Kiama Aged Care Centre of Excellence

## Section 79C Assessment

Application number	DA10.2015.198.1
Site Address	14A Bonaira Street Kiama Lot 1 DP 596755
Proposal	Demolition of existing structures on site with the exception of heritage listed Barroul House.  Construction of: <ul style="list-style-type: none"> <li>• One 134-bed residential aged care facility (RACF).</li> <li>• Three independent living unit (ILU) blocks providing a total of 51 units, including one common basement parking level.</li> <li>• One assisted living unit (ALU) block providing a total of 16 units.</li> <li>• One community support services, activities and administration centre.</li> <li>• Internal roads, pedestrian walkways, utility services and stormwater drainage infrastructure.</li> <li>• Total of 139 car parking spaces at grade and on basement levels.</li> </ul>
Date of lodgement	August 2015
Owner	Kiama Municipal Council
Applicant	Kiama Municipal Council
Submissions	6 objecting, 1 supporting.

Figure 9: 15 Holden Avenue (boffa robertson group).

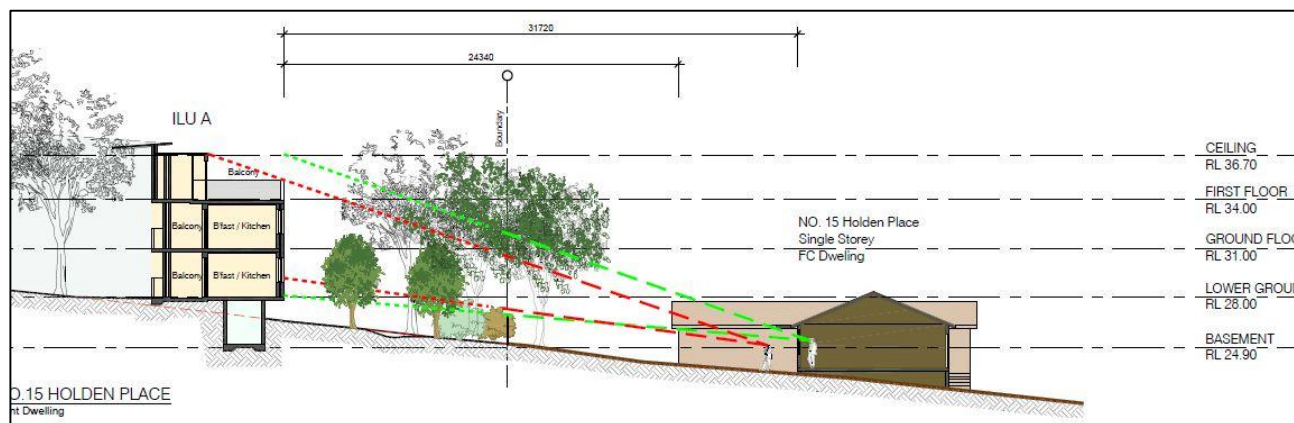
- Portion of third level of ILU A visible from 15 Holden Avenue.
- This is acceptable as the visible bulk is reduced due to third level setback from building line.
- New vegetation planted within setback.

Figure 10: 17 Holden Avenue (boffa robertson group).

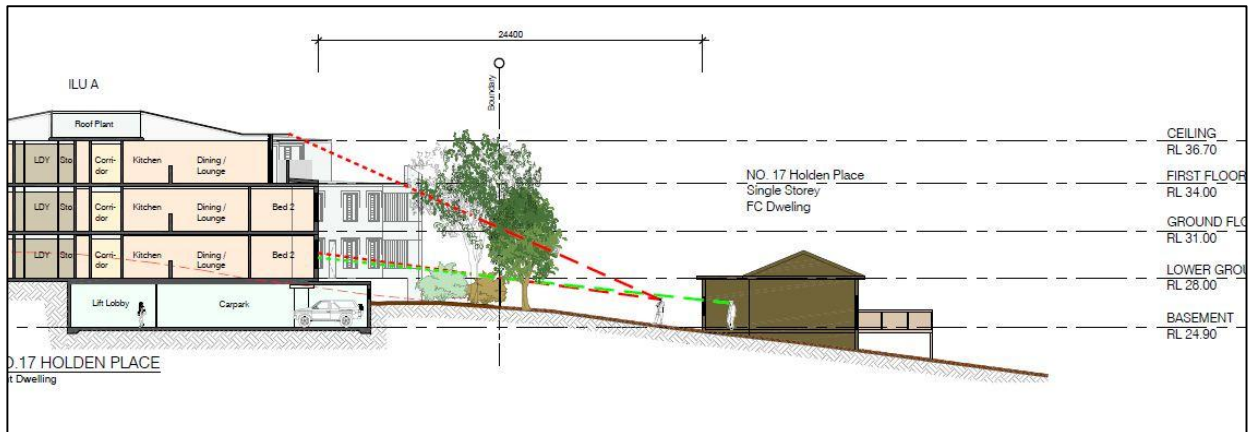
- First level of ILU A visible from within dwelling.
- Third level of ILU A visible from outside dwelling.
- This is acceptable as visible bulk is reduced due to third level setback from building line.

Figure 11: 19 Holden Avenue (boffa robertson group).

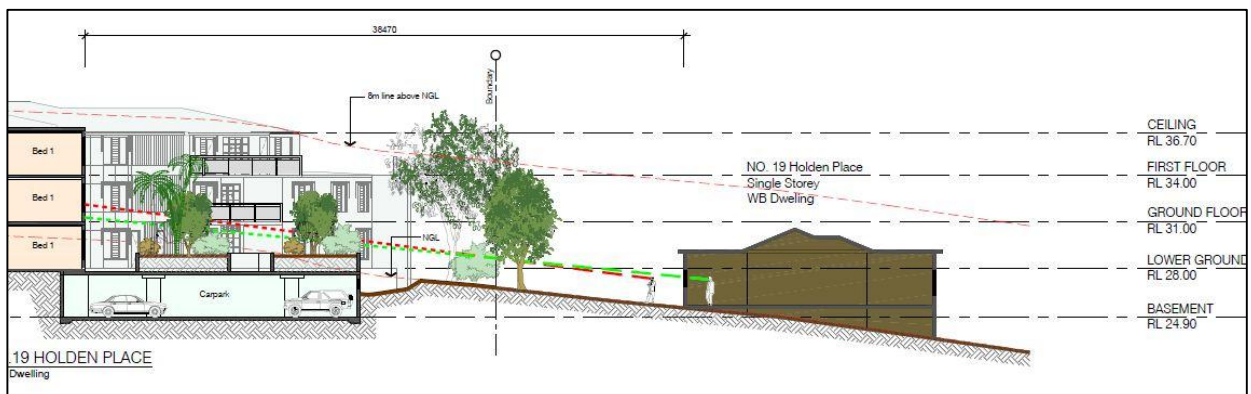
- Second level of ILU A visible from inside and outside 19 Holden Avenue.

Figure 12: 21 Holden Avenue (boffa robertson group).

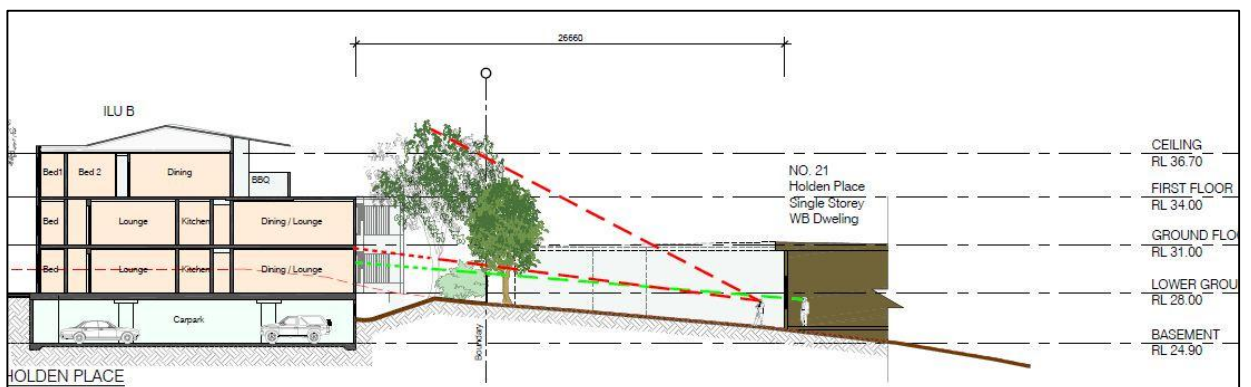
- First level of ILU B visible from within dwelling.
- Third level of ILU B visible from outside dwelling.
- This is acceptable as visible bulk is reduced due to third level setback.

Figure 13: 23 Holden Avenue (boffa robertson group).

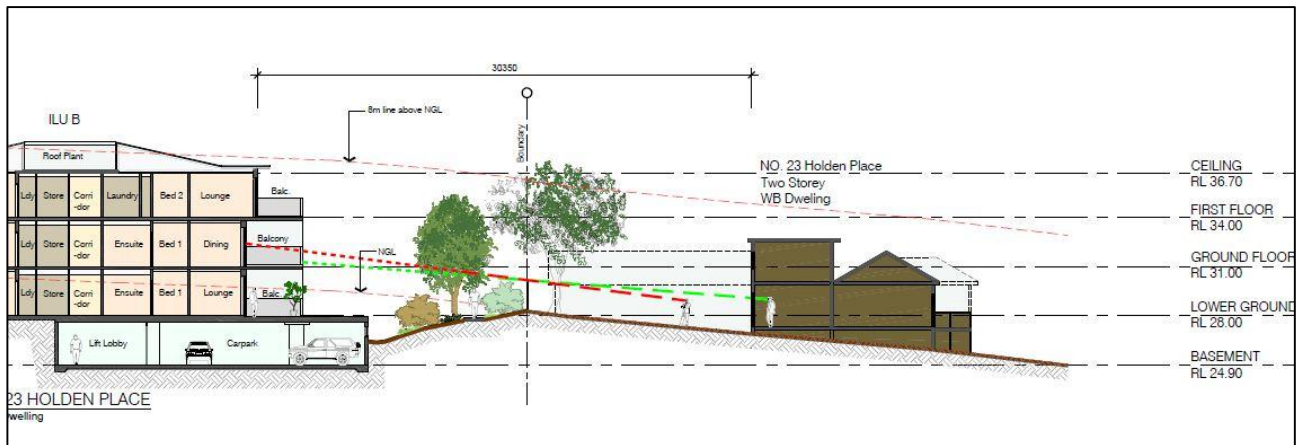
- Second level of ILU B visible from inside and outside dwelling.

Figure 14: 25 Holden Avenue (boffa robertson group).

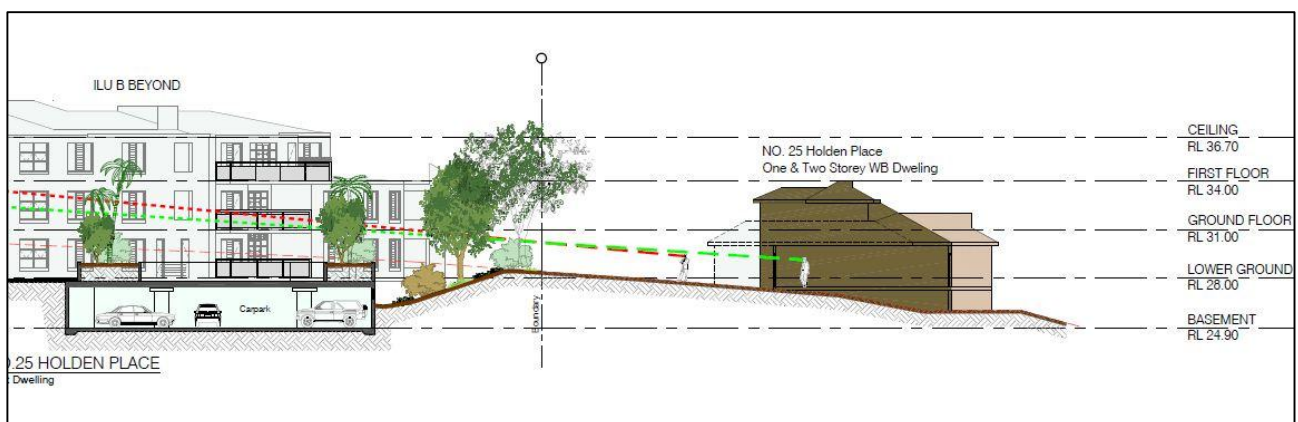
- Sight lines from 25 Holden Avenue are between ILU A and ILU B.

Figure 15: 27 Holden Avenue (boffa robertson group).

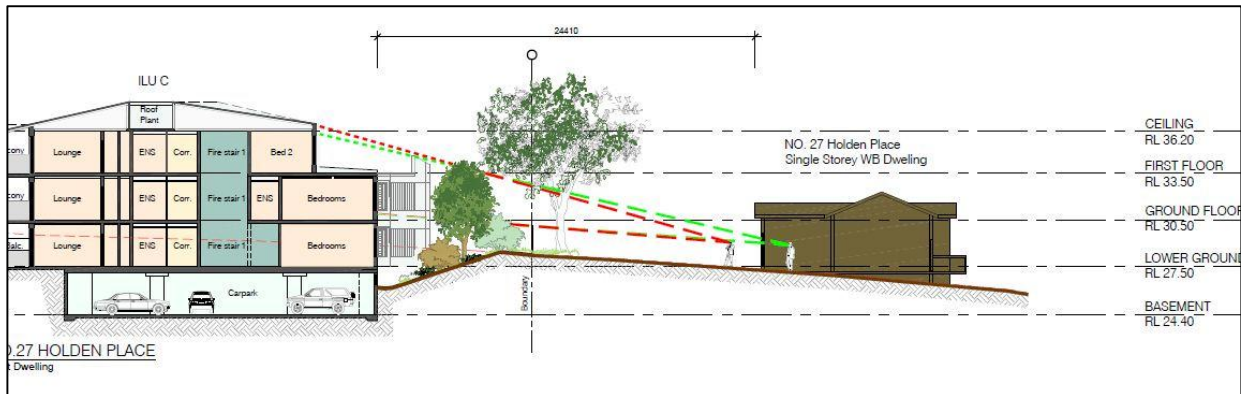
- Third level of ILU C visible from inside and outside dwelling.
- This is acceptable as visible bulk is reduced due to third level setback from building line.

Figure 17: Setbacks along western boundary (boffa robertson group). Setback measurements identified below and this Figure is attached as Appendix C.

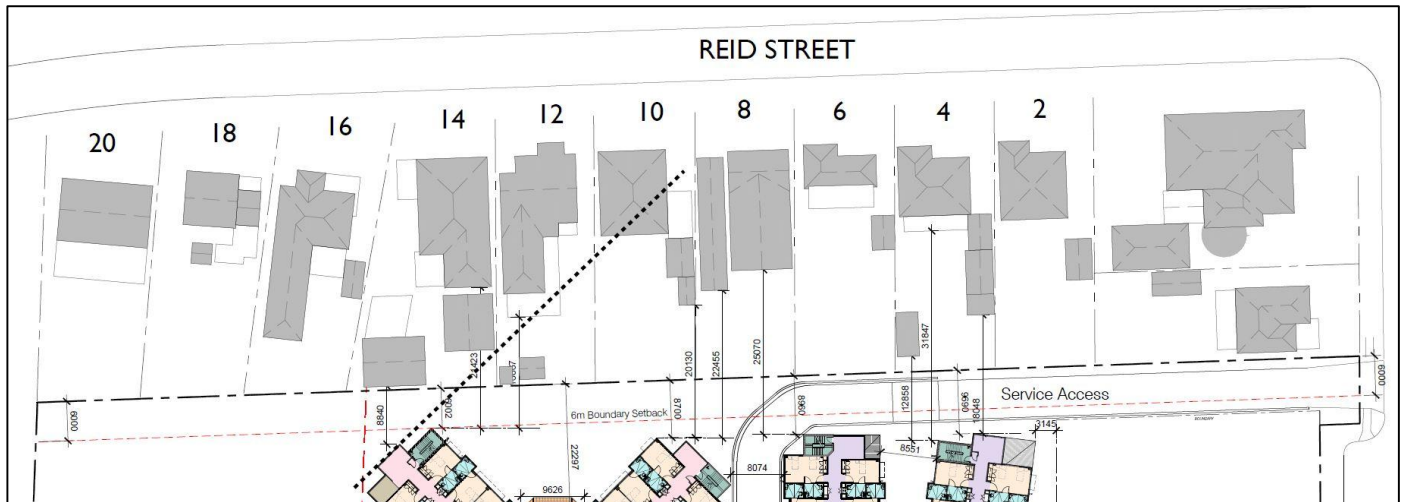
- Figure 17 illustrates that RACF buildings exceed 6 metre setback from boundary.
- The RACF on the western edge of the site is below the minimum height limit.
- 14 and 16 Reid Street identified on Figure 17 above.

Figure 18: 14 Reid Street (boffa robertson group).

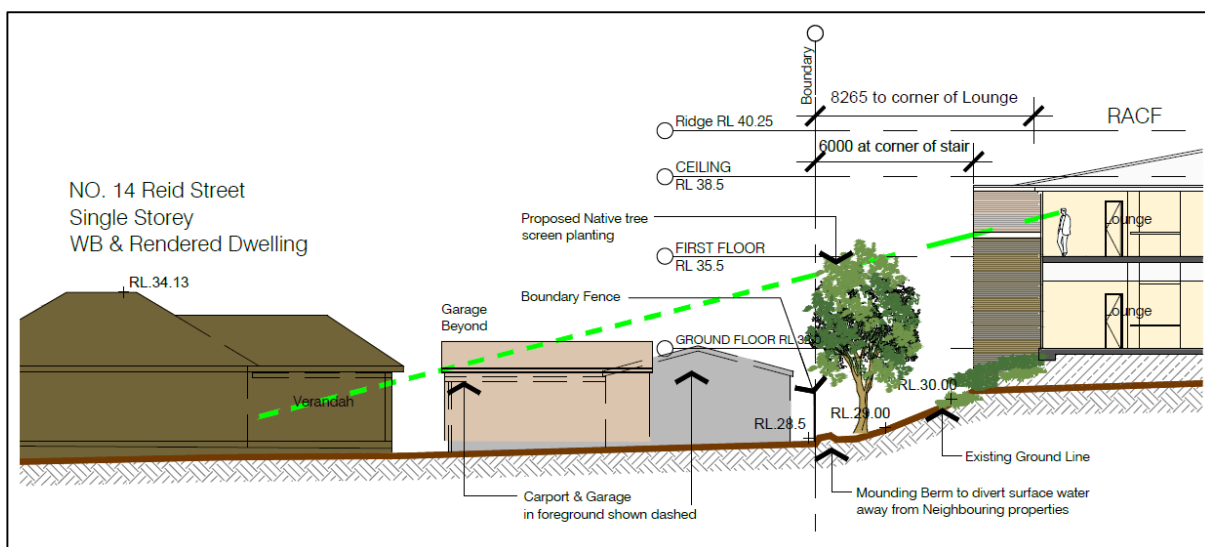
- Building at oblique angle not directly facing 14 Reid Street as illustrated in Figure 18..
- RACF compliant with 6 metre side boundary setback.
- Compliant with height limit.

Figure 19: 16 Reid Street.

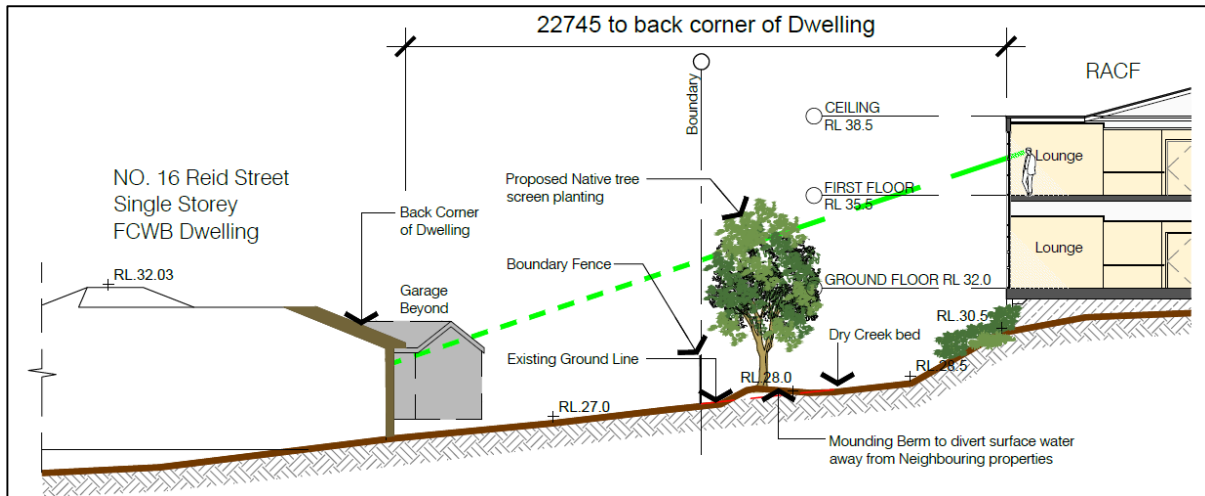
- RACF compliant with 6 metre side boundary setback.
  - RACF will present as two storeys to 16 Reid Street.
  - RACF is two storeys at western boundary and will be viewed as two storeys from 14 and 16 Reid Street.

Figure 20: Location of Community Activities Centre/ALU.

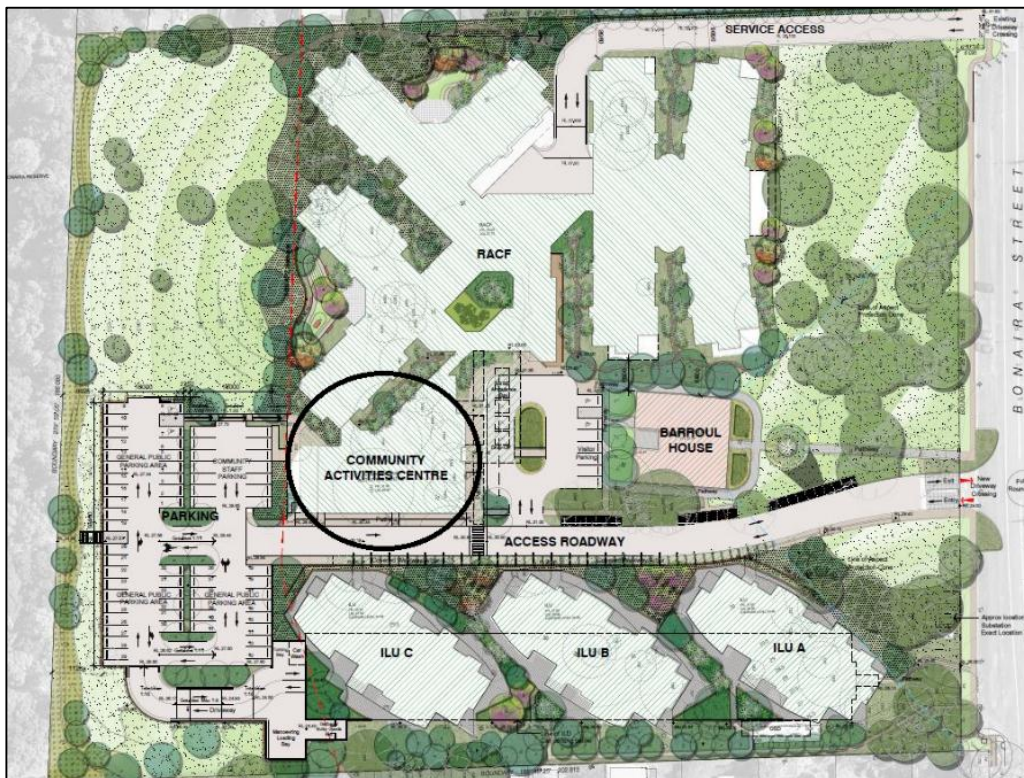
- Vegetative screening assists in reducing apparent bulk of RACF.
- (ii) *using building form and siting that relates to the site's land form,*
- The largest building within the complex, ALU which has height of 11.34 metres and breaches 8 metre height limit by 3.34 metres, is located in the southern portion of the development (see Figure 20).

- This does not impact the amenity of the streetscape as it is over 100m from Bonaria Street and 50m from the neighbouring properties at Holden Street.

- The upper levels will not have a detrimental impact on the residential character of Bonaira Street.

Figure 22: Proposed planting along western boundary (Taylor Brammer). Figure attached as Appendix B.

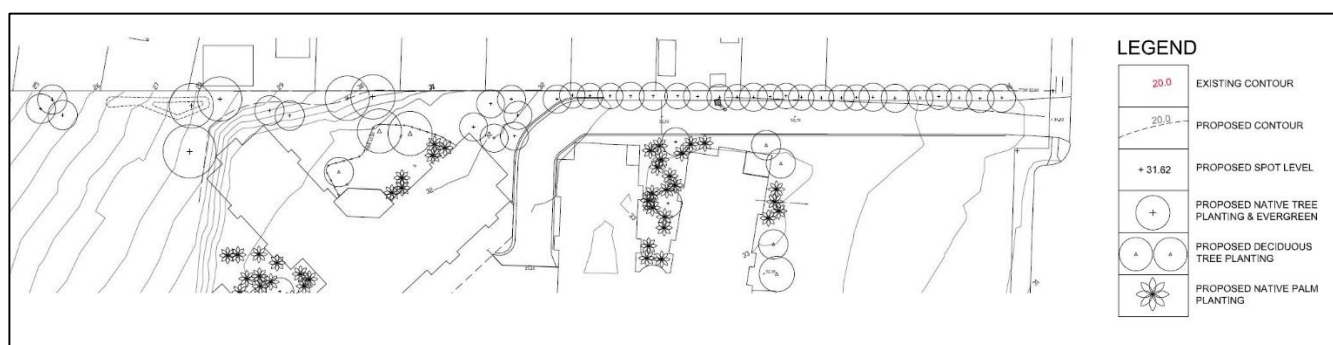
- Setback is a minimum 6m from 14 Reid Street, 8m from 6 Reid Street and 9m from 4 Reid Street.
- Vegetation is proposed between the service lane and Residential Aged Care Facility. Proposed planting along western boundary will screen the RACF and prevent overlooking into Reid Street properties (see Figure 22). The Residential Aged Care Facility is only two storeys. Bedrooms windows are oriented form the neighbouring properties to avoid overlooking into the rear setbacks of Reid Street.
- Figures 18 and 19 in Section 2.1.1 indicate how overlooking from the southern RACF Lounge area to 14 and 16 Reid Street is minimised through vegetative screening along the western boundary.

Figure 26: Impacted properties identified in red.

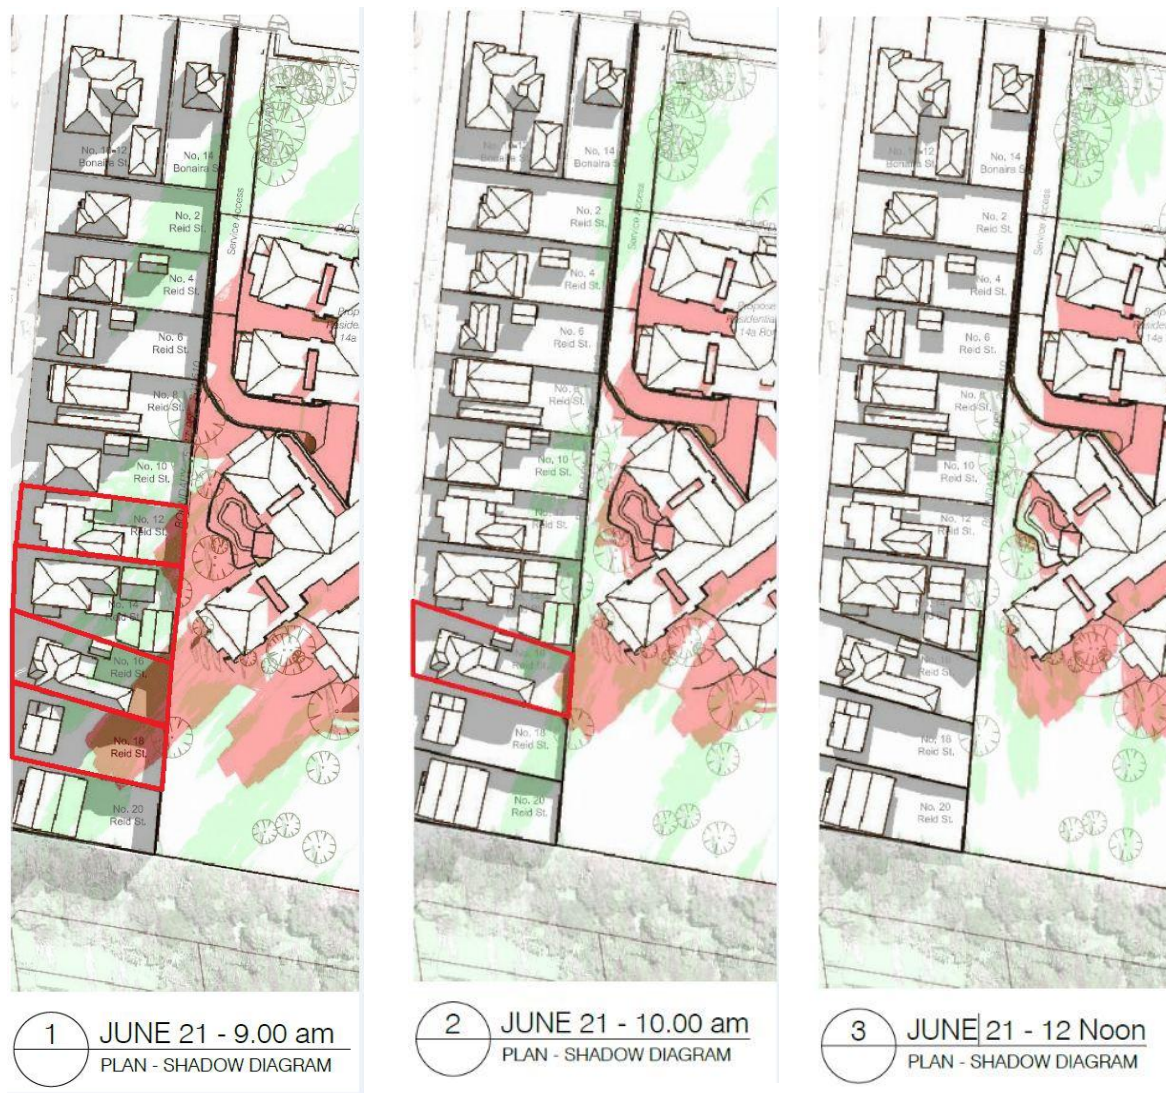
- 2-20 Reid Street dwellings currently get uninterrupted solar access.
- Rear setback 12-18 Reid Street are impacted by shadow of south western portion of RACF between 9.00am and 10.00am. The rear yard of these properties get sunlight between 11 and 3pm.
- Rear Setback of 12 and 14 Reid Street are impacted by shadow of western wing of RACF at 9.00am. The rear portion of the yard is not impacted between 10 and 3pm.
- 2 to 10 Reid Street and 14 Bonaira Street do not receive any shadow impacts.

The proposed bulk and scale of the Residential Aged Care Facility do not have unreasonable impacts on the neighbouring properties on Reid Street or 14 Bonaira Road.

Figure 27: Impacted properties identified in red.

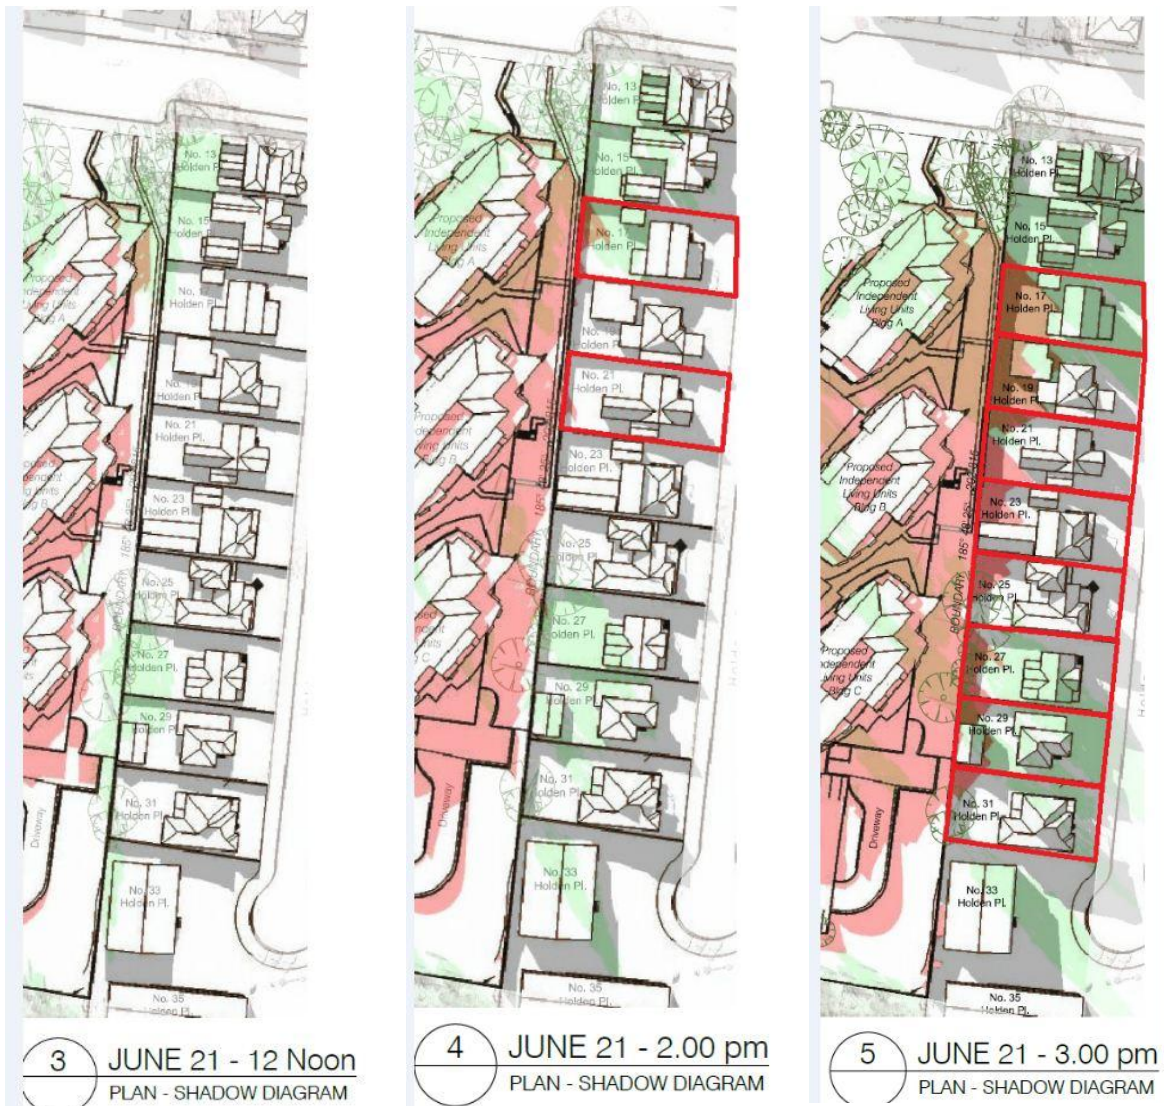
- Rear Setbacks of Holden Avenue properties are not impacted by shadows between 9 and 2pm except for a portion of rear setback of 17 and 21 Holden Avenue where there is overshadowing from 2pm onwards.
- 19 Holden Avenue is overshadowed by ILU A from 3pm onwards.
- 21-25 Holden Street have less than half of their rear yards overshadowed by ILU B at 3pm.
- Half of the rear yards for 25-31 Holden Street are overshadowed by ILU C's shadow from 3pm onwards.

The bulk and scale of the Independent Living Units do not have an unreasonable impact on the living areas or private open space of neighbouring properties at Reid Street.
